Marked-up Revised Response
to NRC RAI No. 02.05.01-17 (eRAI 6024)

The following revised text in the last paragraph of FSAR Subsection 2.5.1.2.2, Site Area Stratigraphy, and additional paragraphs will be included in a future revision of the COLA.

The following revised text will be included in a future COLA revision to replace paragraphs 7 through 14 of FSAR Subsection 2.5.1.2.4, Site Geologic Hazards.

Figure 2.5.1-353 The two zones of secondary porosity on B-710 G (DH) showing the lithology, caliper, natural gamma, velocity (Vs and Vp) and acoustic televiewer logs (5 pages)

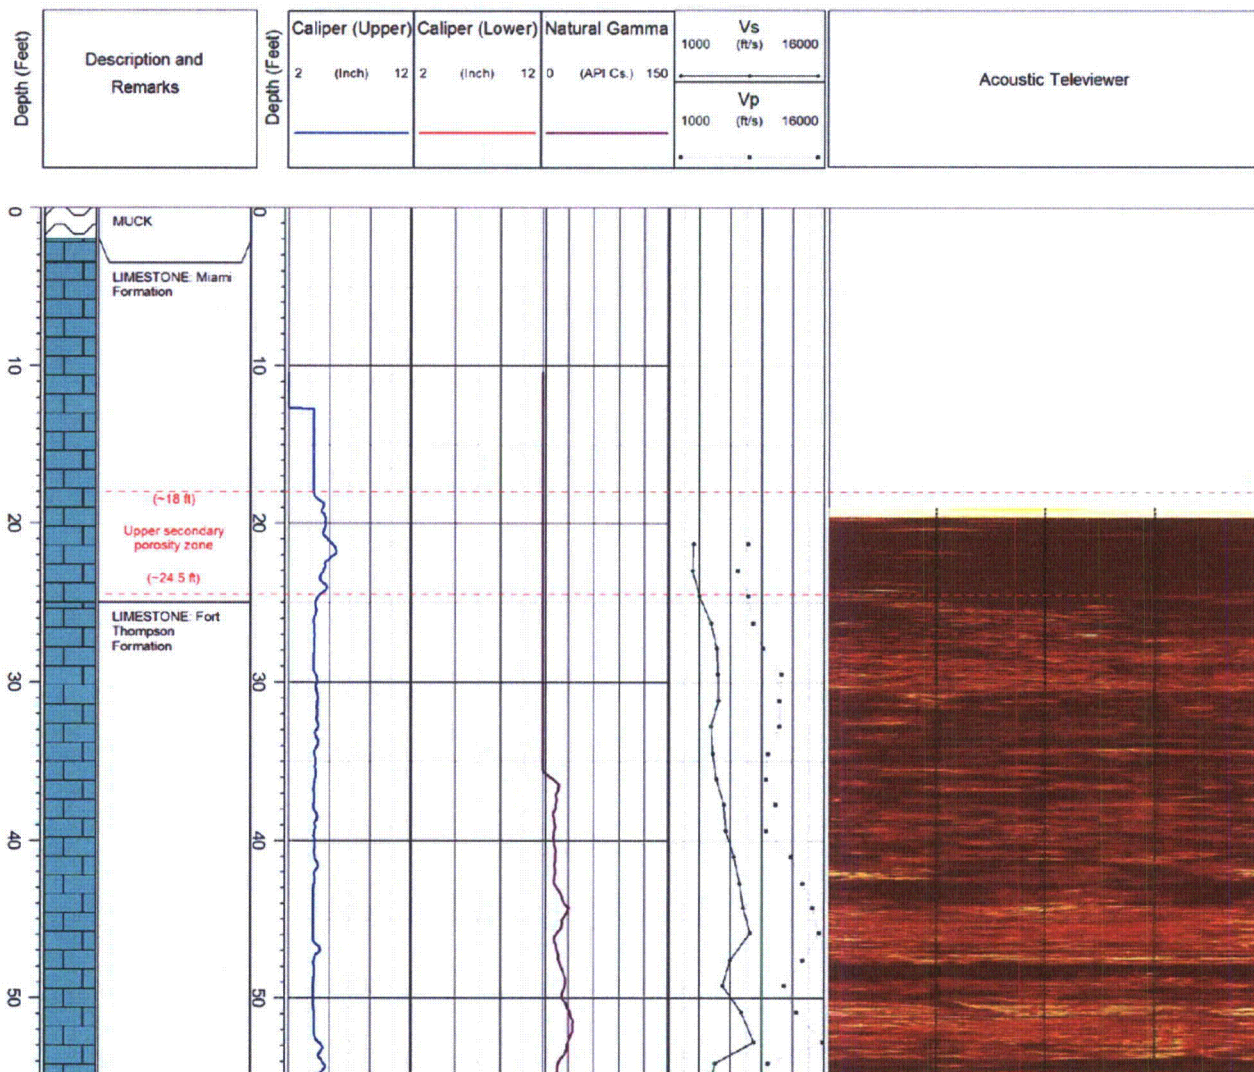
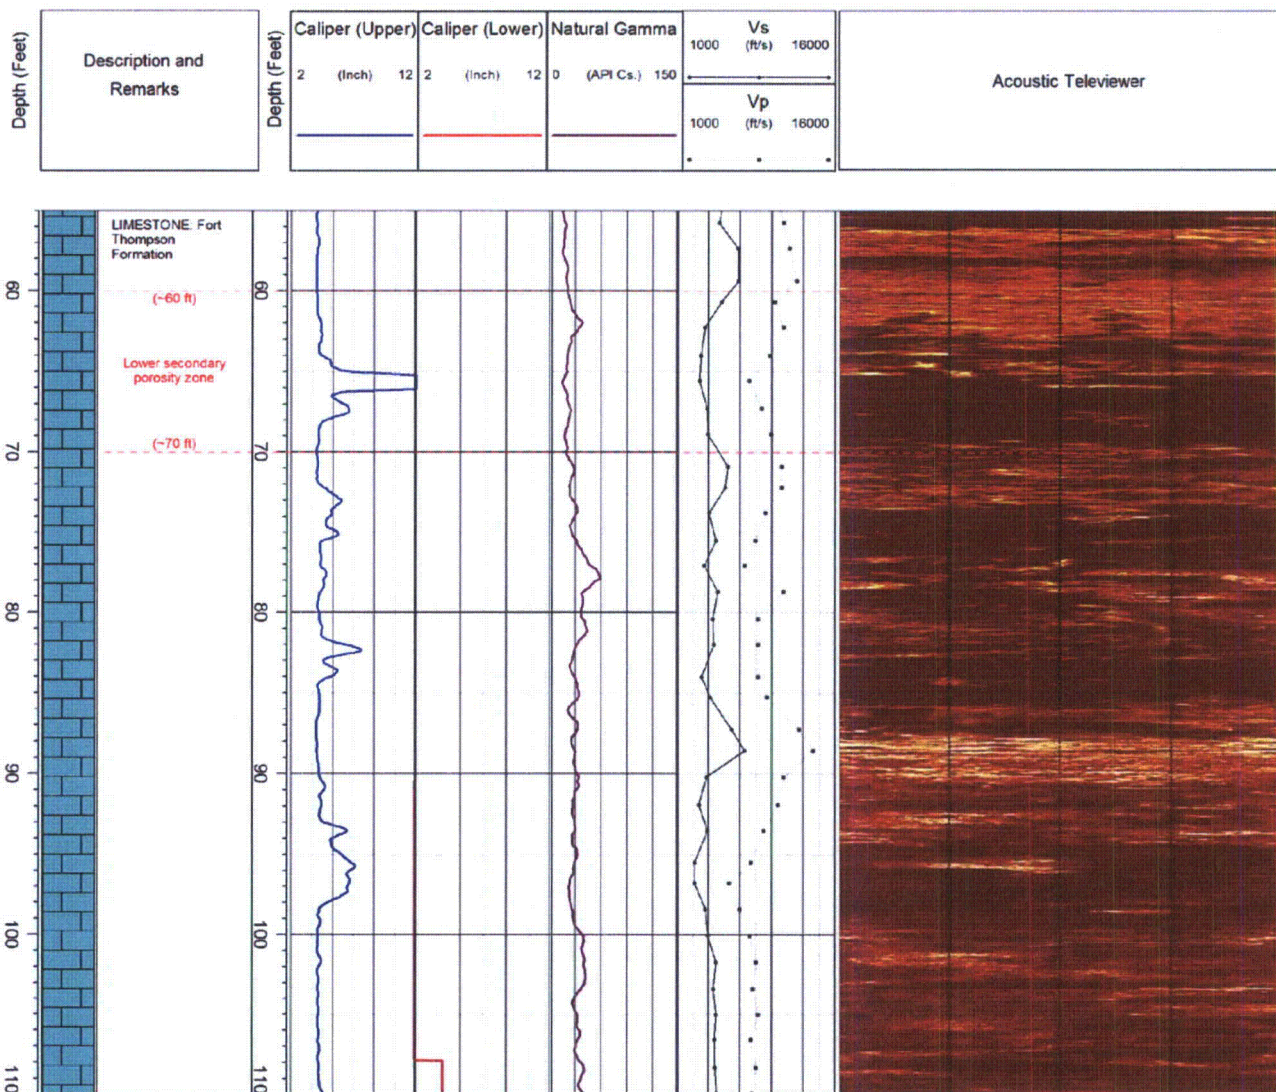
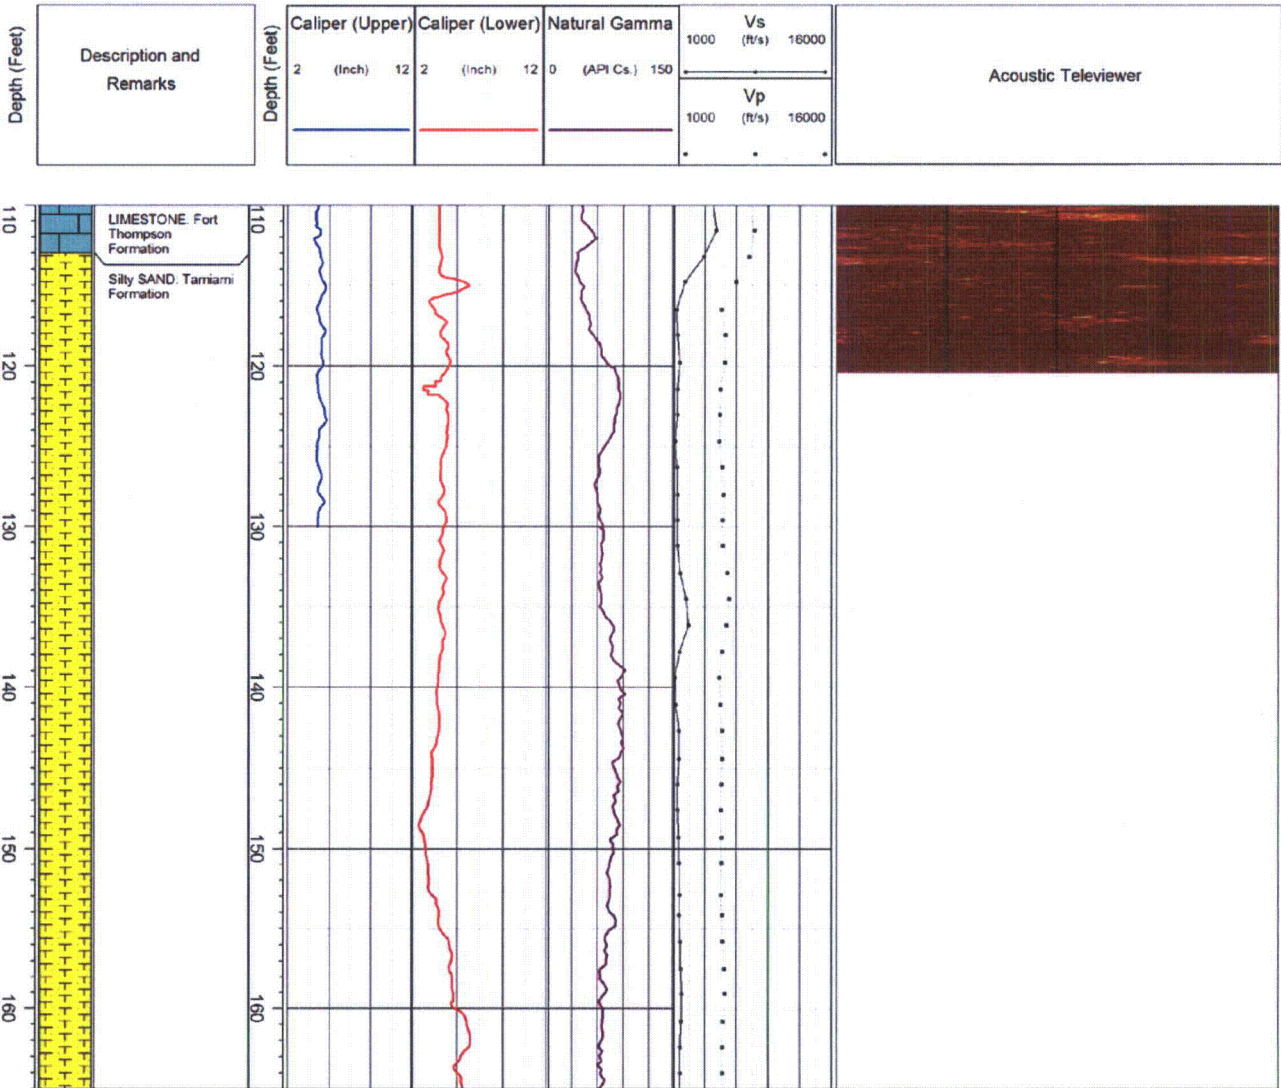
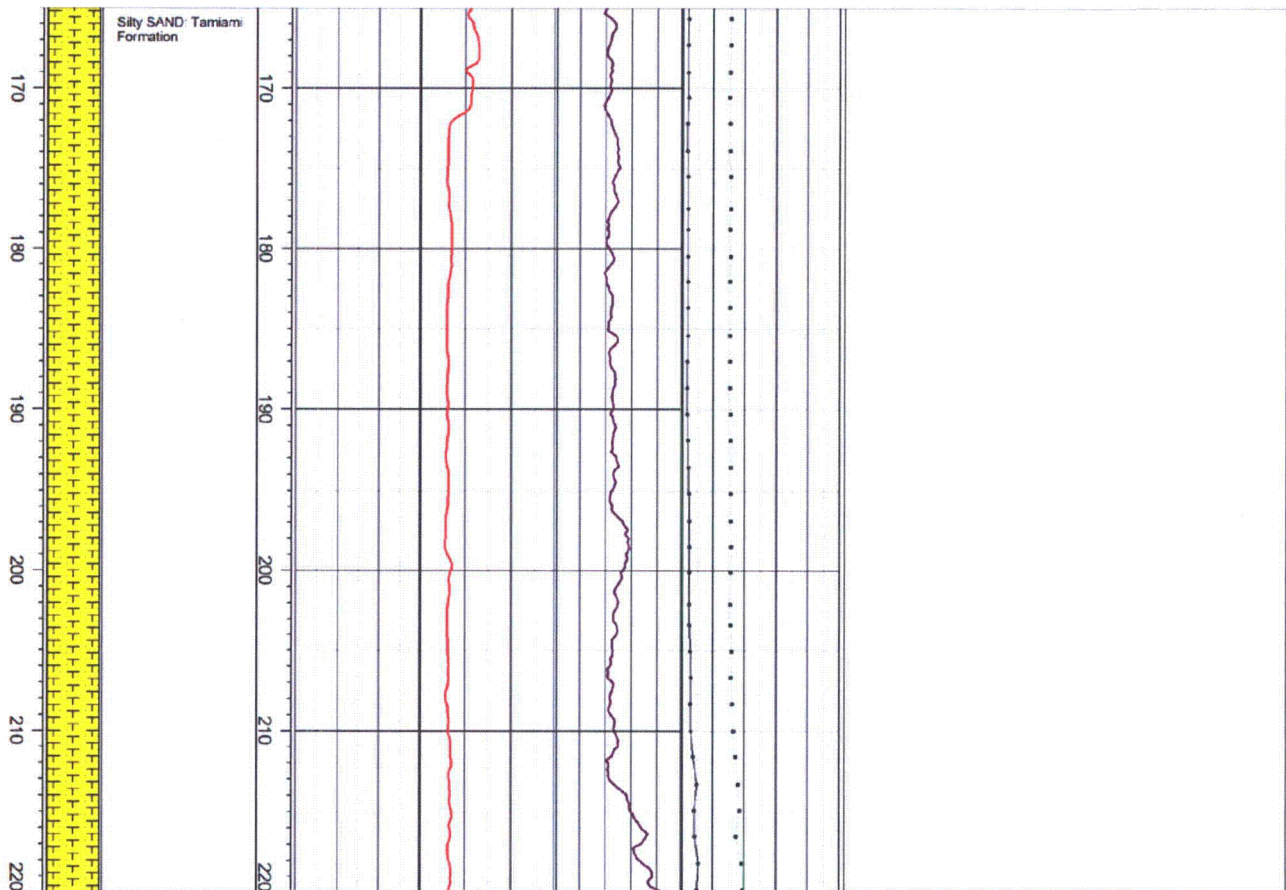
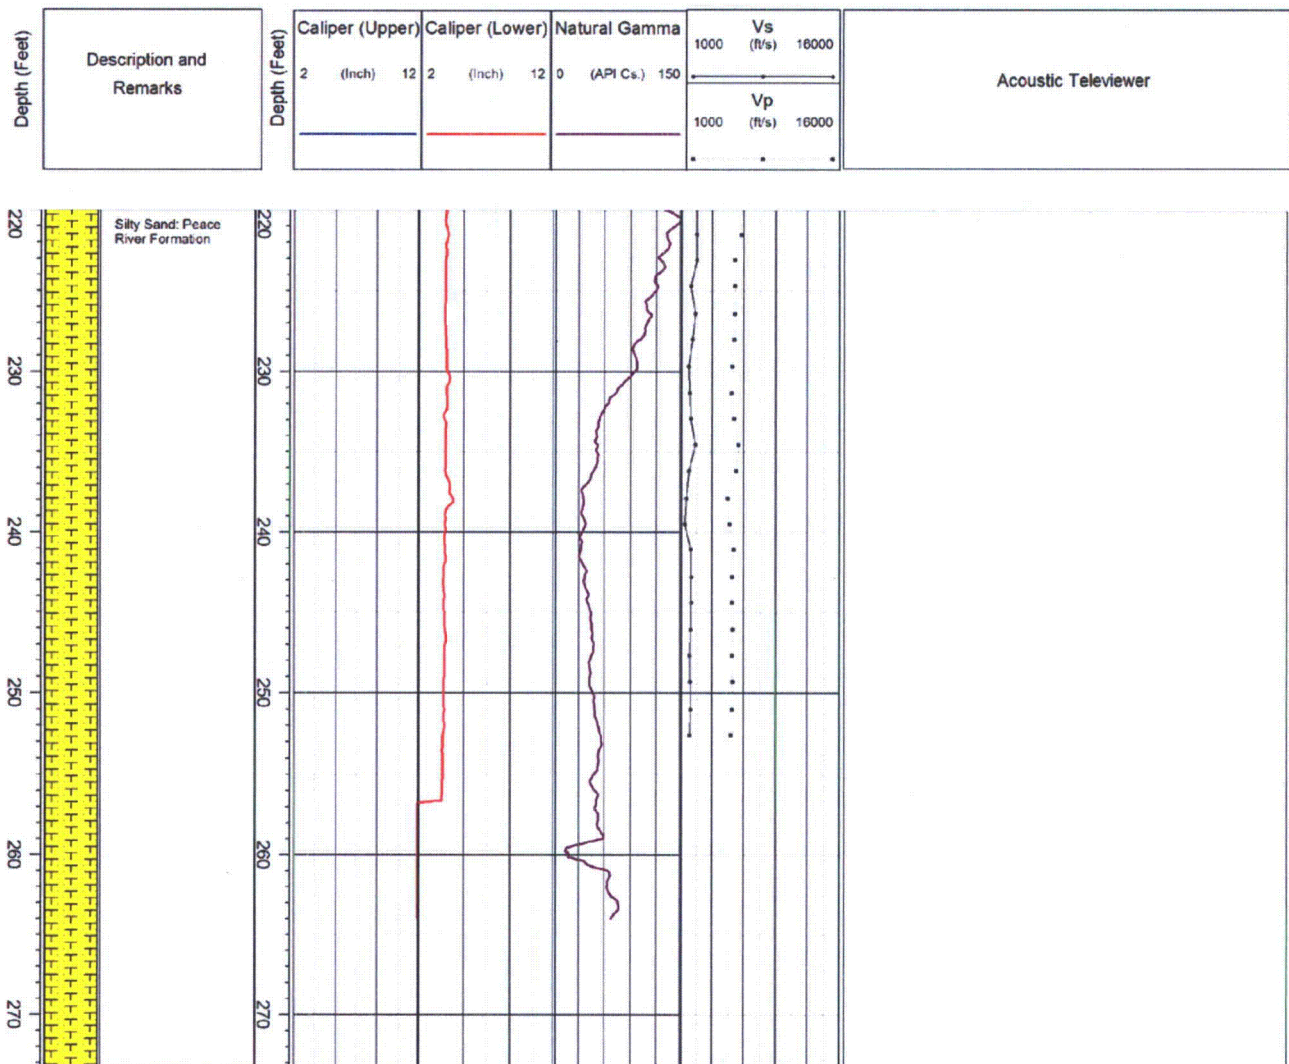
Touching-vug porosity occurs on the site within the approximate depth interval of 20 to 35 feet (Figures 2.5.1-351, 2.5.1-352, and 2.5.1-353) near the contact of the Miami Limestone and Key Largo Limestone (the "Upper Zone" of secondary porosity discussed in FSAR Subsection 2.4.12.1.4). Because the elevation of ground surface at the site is approximately 0 feet NAVD88 (Reference 708), this depth interval corresponds approximately to -20 to -35 feet NAVD88. The origin of this porosity is solution enlargement of burrows, inter-burrow vugs, moldic fossils, root molds, and vugs between root casts (References 404, 723 and 969). These structures are sufficiently numerous and closely spaced so as to form a laterally continuous zone of interconnected voids. Results of drilling and coring within the zone of touching-vug porosity during the site subsurface investigation have shown the feature to be laterally persistent, generally of centimeter scale, with very few indications of possible larger voids such as a rod drop.

Moldic porosity occurs in pockets within the approximate depth interval of 60 to 75 feet (-60 to -75 feet NAVD88) (Figures 2.5.1-351, 2.5.1-352, and 2.5.1-353) in the Fort Thompson Formation and forms the "Lower Zone" of secondary porosity discussed in FSAR Subsection 2.4.12.1.4. The origin of this feature is preferential dissolution of fossil shells and other organic structures rather than the matrix rock within which they are contained, resulting in void spaces of generally centimeter scale within molds of the structures (References 404, 723 and 969).
